Access Compliance Report

Public Rights-of-Way

(Curb Ramps)

Intersection ID: 26975	Main Street: SOUTH_HALL_DR	Cross Street: WARWICKSHIRE_LN	Location: SE
ADA ID: E157E81E90E2	Ramp Type: PerpDiag	Initial Pass/Fail: Fail	Overall Compliance: No
		Severity Score: 8.75

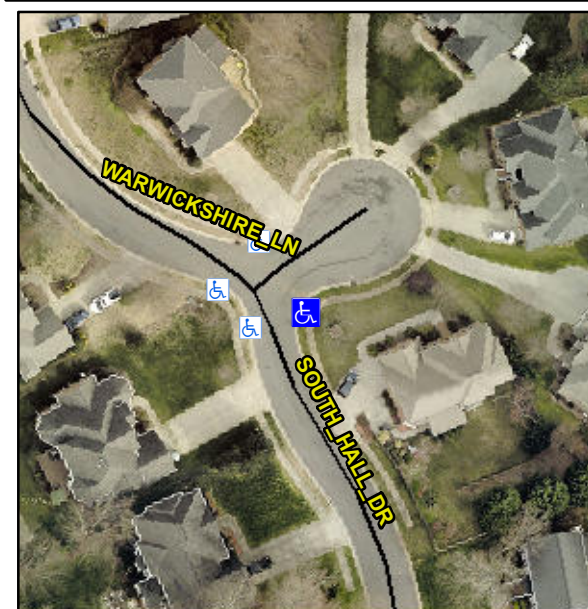
Not Found, R304.5.1

Compliance	Description	Data	Compliance	Description	Data
N/A	Ramp Length (in)	49.5	Yes	Ramp Slope (%)	7.3
No	Ramp Width (in)	37.5	Yes	Ramp XSlope (%)	0.5
N/A	Flare Type LT	N/A	N/A	Flare Type RT	N/A
N/A	Flare Slope LT (%)	N/A	N/A	Flare Slope RT (%)	N/A
N/A	Flare Traversable LT?	N/A	N/A	Flare Traversable RT?	N/A
N/A	Landing Length (in)	N/A	N/A	DWS Provided?	N/A
N/A	Landing Width (in)	N/A	N/A	DWS Contrast?	N/A
N/A	Landing Slope (%)	N/A	N/A	DWS Length (in)	N/A
N/A	Landing X Slope (%)	N/A	N/A	DWS Full Width?	N/A
N/A	Landing Curb? (Y/N)	N/A	N/A	DWS Offset (in)	N/A
N/A	Shared Landing?	N/A			
N/A	Gutter Ponding?	N/A	N/A	Gutter Slope (%)	N/A
N/A	Gutter Lip Ht (in)	N/A	N/A	Gutter X Slope (%)	N/A
N/A	Painted X Walk1?	No	N/A	Painted X Walk2?	No
	X Walk 1 Direction	To N		X Walk 2 Direction	To W
N/A	X Walk 1 Width (in)	N/A	N/A	X Walk 2 Width (in)	N/A
	X Walk 1 Slope (%)	3.9		X Walk 2 Slope (%)	1.3
	X Walk 1 X Slope (%)	2.3		X Walk 2 X Slope (%)	1.5

Remove & Replace Curb Ramp With Two New Directional Ramps or Equivalent.
